**Submission for Compliance with Approval Condition (d)
– the Submission of a Revised Drainage Proposal**

**Proposed Temporary Warehouse (excluding Dangerous Goods Godown) with
Ancillary Facilities for a Period of 3 Years and Filling of Land in “Agriculture” Zone,
Lot 748 (Part) in D.D. 107, Fung Kat Heung, Kam Tin, Yuen Long, New Territories**
(Application No. A/YL-KTN/907)

Appendix I – Response to the Comments of Chief Engineer/Mainland North, Drainage Services Department (CE/MN, DSD)

Drawing No.	Ver.
APPENDIX I	01
Project	
PROPOSED TEMPORARY ANIMAL BOARDING ESTABLISHMENT FOR A PERIOD OF 5 YEARS AND LAND FILLING LOT 748 (PART) IN D.D. 107 FUNG KAT HEUNG, KAM TIN YUEN LONG, NEW TERRITORIES	
Drawing Title	
DRAINAGE PROPOSAL	
Scale of A4	
1 : 200	
Drawn	Date
	6.3.2023
Revised	Date

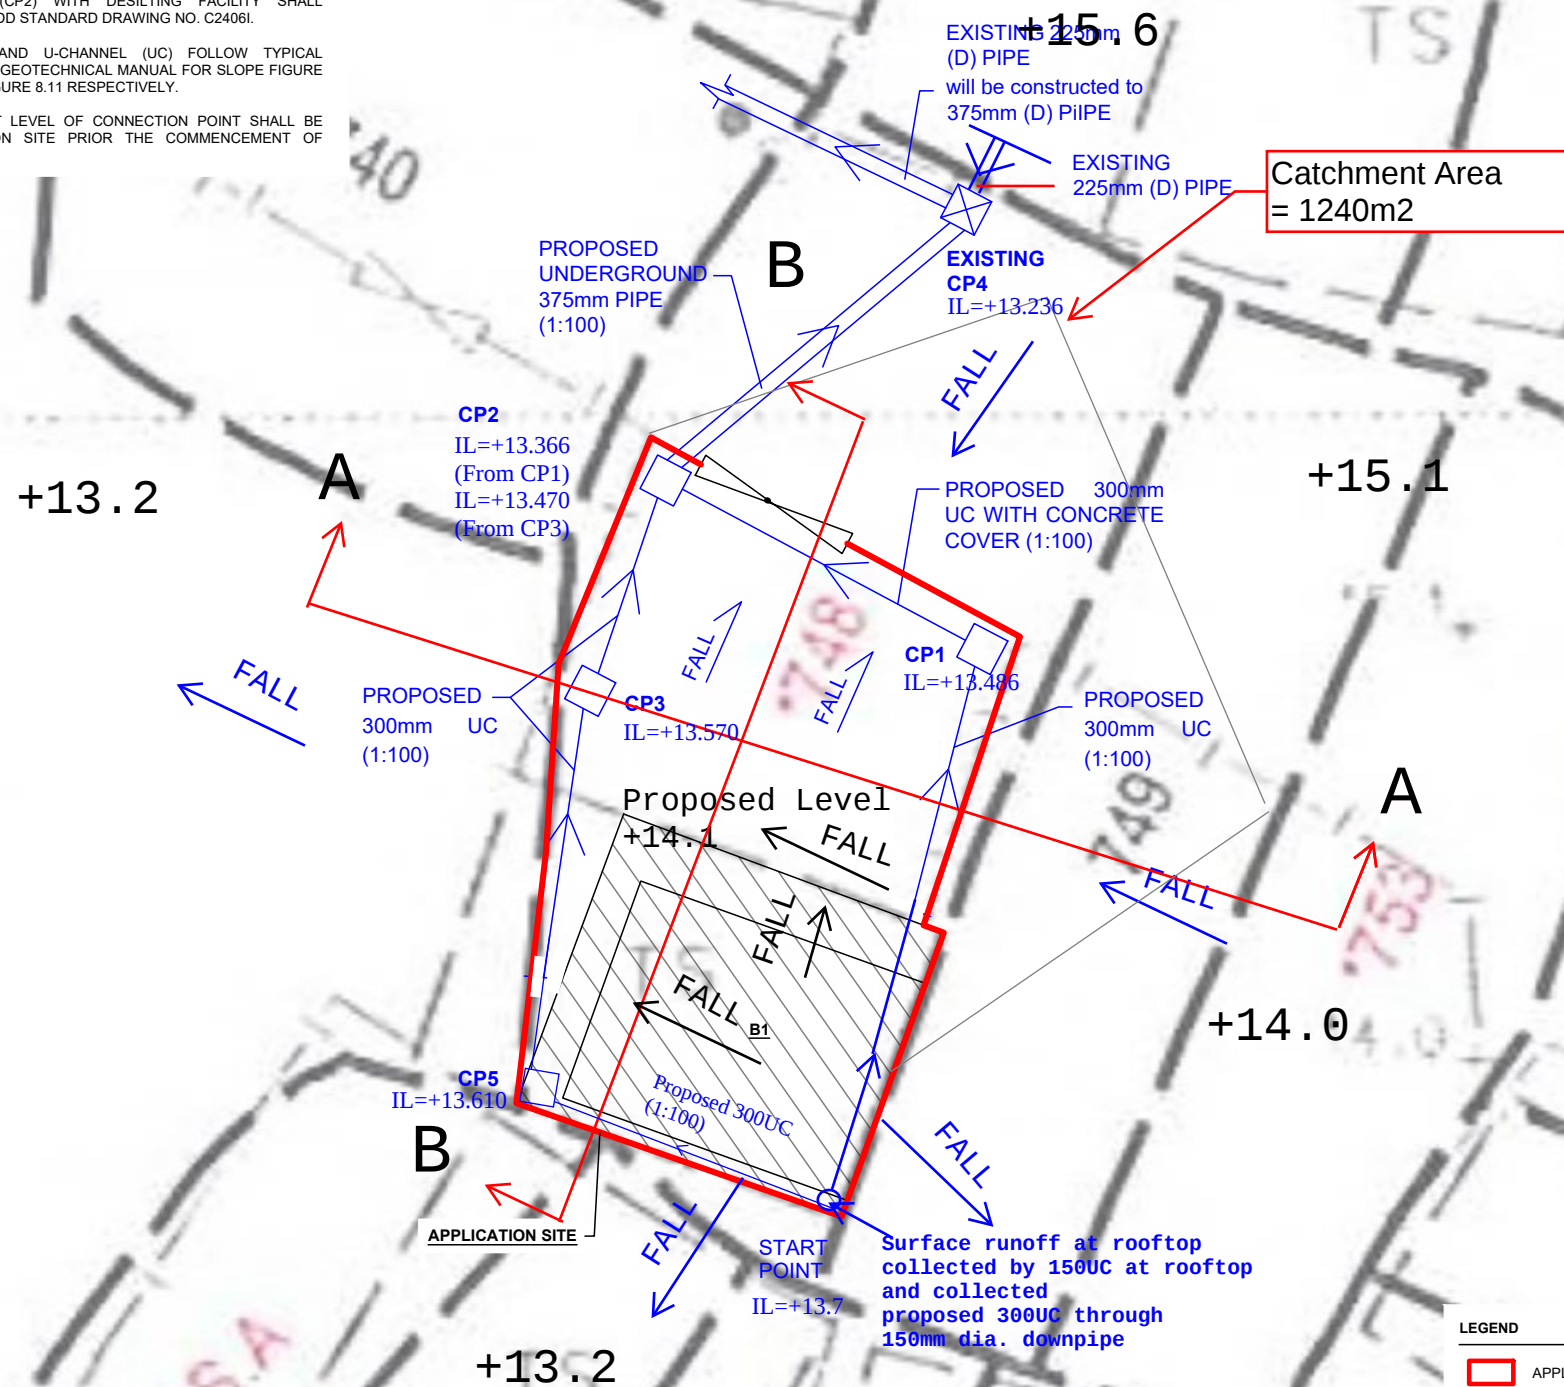
(3)	Drawing No. Appendix I - Please review if the downpipe size is 1500mm dia.	Noted and revised accordingly (Appendix II).
(4)	Please justify with the fall direction of the southern and eastern side of building structure. If no strong justification can be provided, peripheral drains are required.	Peripheral drains are proposed and indicated on the drainage plan (Appendix II).

Surface runoff at rooftop collected by 150UC at rooftop and collected proposed 300UC through 150mm dia. downpipe

150mm Rooftop Peripheral channel

GEO Technical Guidance Note No. 43 (TGN 43)
Guidelines on Hydraulic Design of U-shaped and Half-round Channels on Slopes

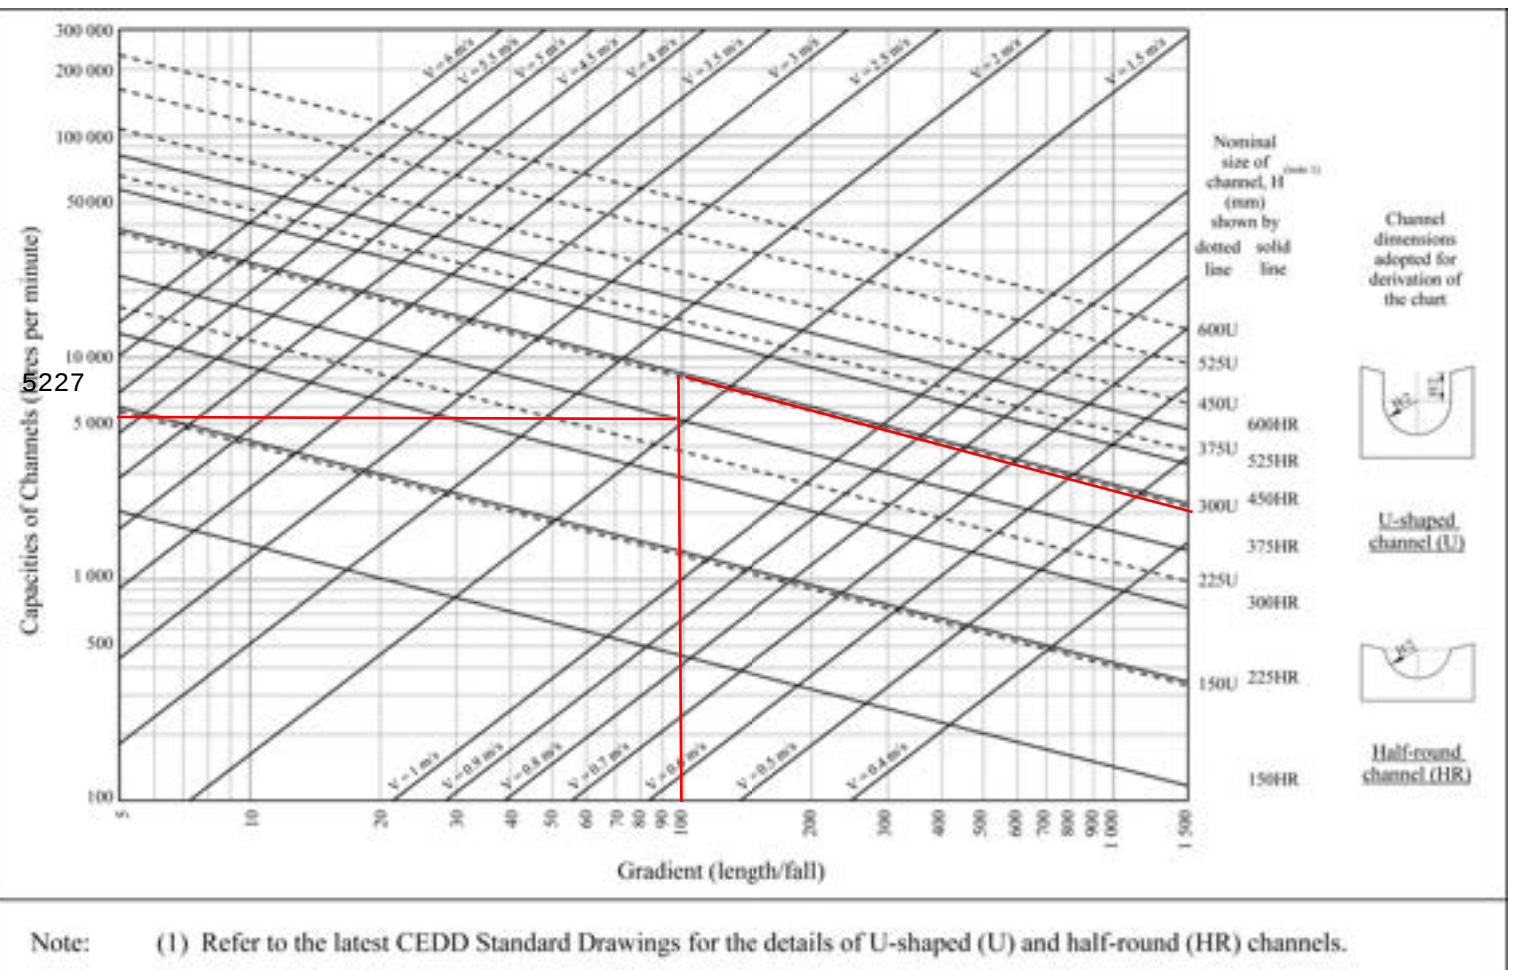
Comments of the CE/MN, DSD (Contact Person: Mr. Terence TANG; Tel:)		
(1)	GEO Technical Guidance Note No. 43 should be adopted for u-channel checking as Figure 8.7 of the Gcotechnical Manual for Slopes (GCO, 1984) was superseded.	Noted and revised accordingly (Appendix II).

SITE PHOTO

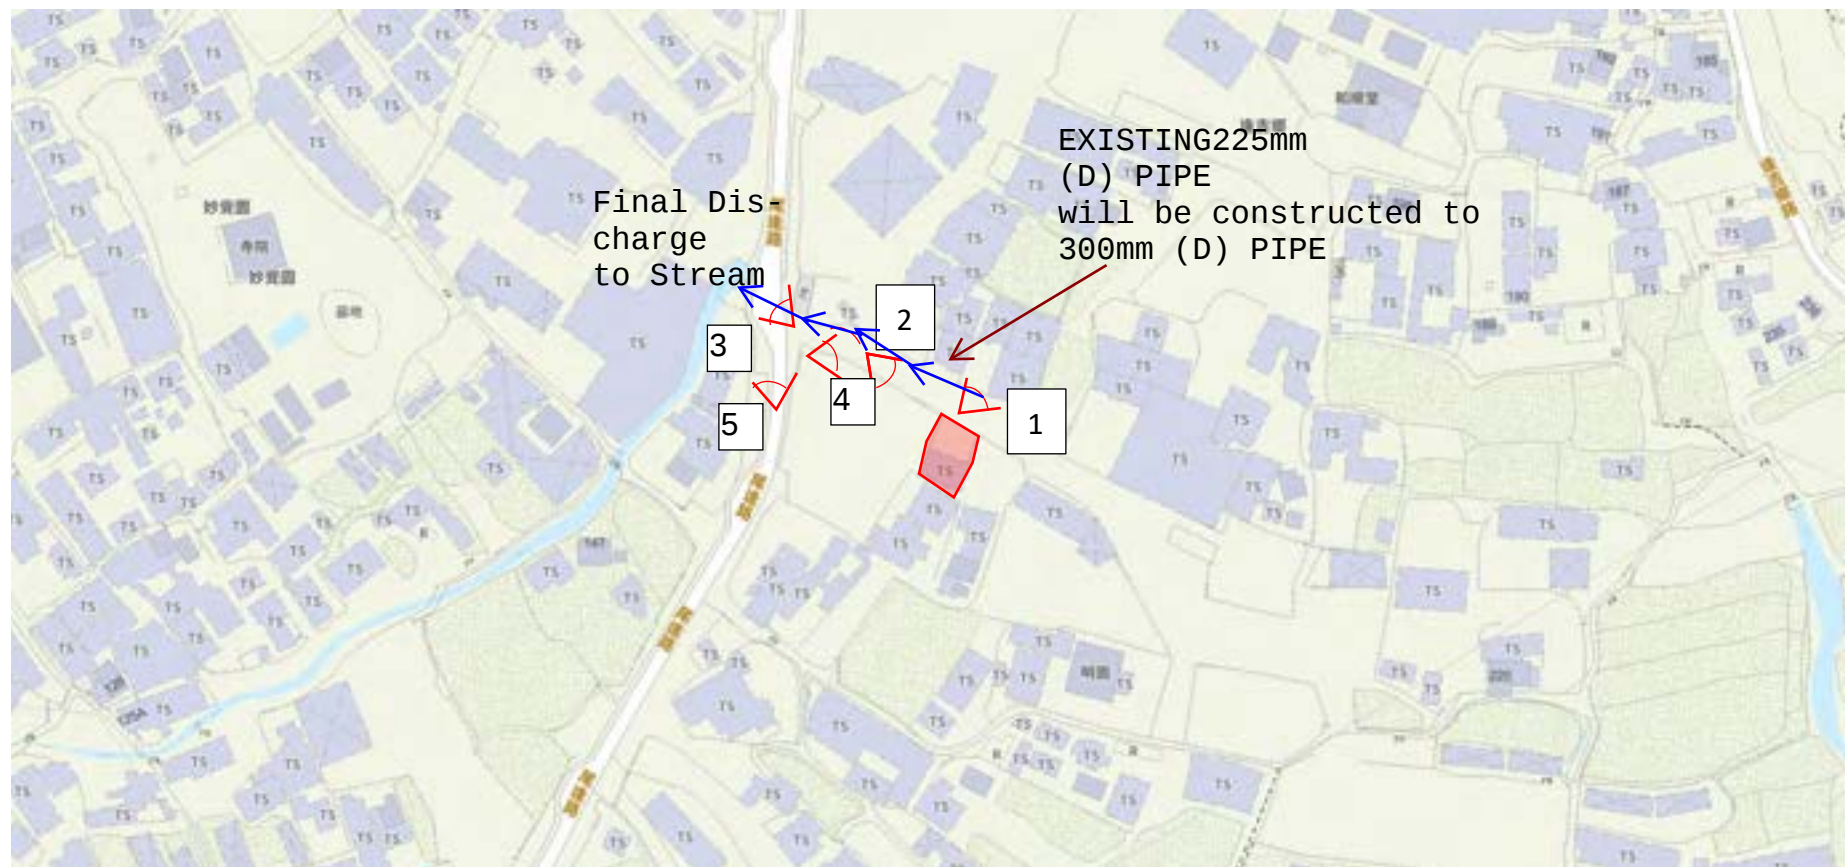
(5)	Photo 1 - It is noted there is another pipe installed under 225mm dia. uPVC from A/YL-KTN/605. Please advise where is the pipe connecting to. The catchment area from this pipe should also be considered in the assessment.	It is considered as follows:  Catchment area of A/YL-KTN/605 is considered in Appendix II shown as follows:

(6)	Photo record for final discharge to existing stream should be provided. Please provide latest actual photo record instead of capture from google map or alike.	Noted. Photo record is revised ,which has been taken in this year (Appendix II).

Existing Condition of CP4 and existing 225mm dia. pipe
